You will find enclosed Service Bulletin S06KH regarding the air operated entrance door emergency release lever.

Air Door Switch Guard

MODELS AFFECTED: BBCV with Option 0022202, Emergency Release, Air Powered Doors Relocation

Finished installation

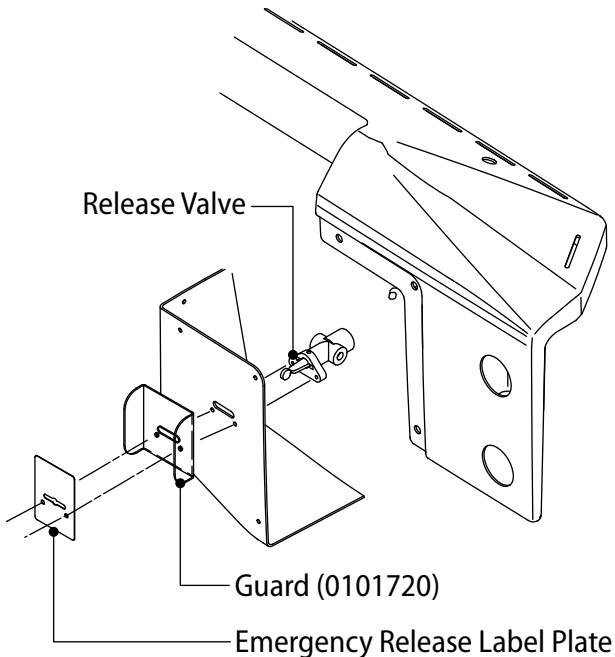
During entry or exit, passengers' jacket pockets, book bag straps, etc., may snag the front dash mounted emergency release lever for air powered entrance doors.

This procedure describes installation of a guard to prevent accidental snagging and tripping of the emergency release lever.

- 1** Secure the bus for service: Park vehicle on level surface. Apply parking brake. Turn off ignition. Remove key.
- 2** Remove the two 10-16 x 3/4" screws which secure the Air Entrance Door Emergency Release plate. Remove the plate.
- 3** Position the slot of the provided guard (part number 0101720) over the emergency release lever and align the two mounting holes. Position the slot of the Air Entrance Door Emergency Release Plate over the emergency release lever and align the mounting holes. Reinstall the two screws removed in step 2.
- 4** Operate the switch to inspect for proper operation. This procedure is complete, and the bus may be returned to service.
